## Access Compliance Report Public Rights-of-Way (Curb Ramps)

Intersection ID: 48373 Main Street: WHEATFIELD\_RD Cross Street: GARDEN\_VIEW\_DR Location: S

ADA ID: F02F5DF19596 Ramp Type: BlendTrans1 Initial Pass/Fail: Pass Overall Compliance: No Severity Score: 5

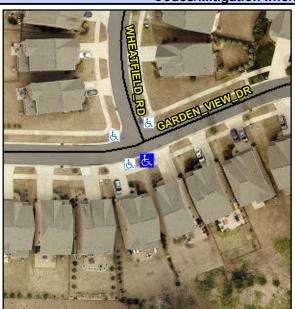
Not Found, R304.2.2-Perp, R304.3.2-Para, R304.5.4

Remove & Replace Curb Ramp With Two New Directional Ramps or Equivalent. Remove & Replace Gutter.
